Site Control Modification Manual 14H Update

December 2024 Markets and Reliability Committee

Manual 14H – Section 4.9.2

Exhibit 10: Generator Interconnection into Existing TO Substation

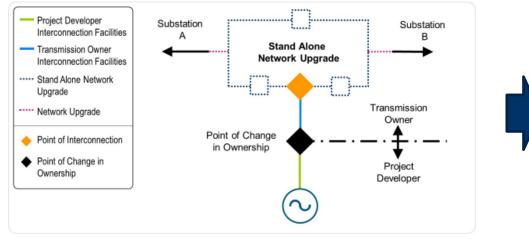
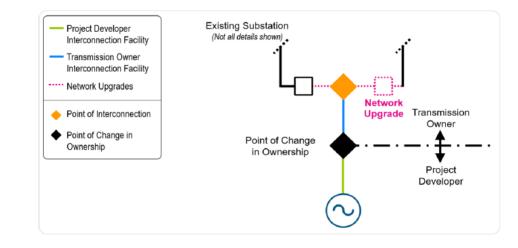
- In M-14H Section 4.9 shows diagrams of typical New Service Request Connection Types
- Exhibit 9 shows "Generator Interconnection via New Interconnection Switchyard"
- Exhibit 10 is supposed to show "Generator Interconnection into Existing TO Substation" but instead is the same diagram used in Exhibit 9

- PJM seeks to correct Exhibit 10
- PJM seeks to provide greater clarification on how Developers can meet tariff requirements for Site Control and what Site modifications are allowed under the tariff
- As PJM continues progress through TC1 and TC2 applications are due in Q4 2024, it is important for Developers to understand what Site Control modifications are allowed under the tariff in order to be able to continue to develop their projects and meet tariff requirements for Site Control at various points of the Interconnection Cycle process

4.9.2 Generator Interconnection into Existing Transmission Owner's Substation Exhibit (Generator Interconnection into Existing TO Substation) depicts a generator interconnecting to an existing Transmission Owner substation which needs to be expanded to accommodate the interconnection.
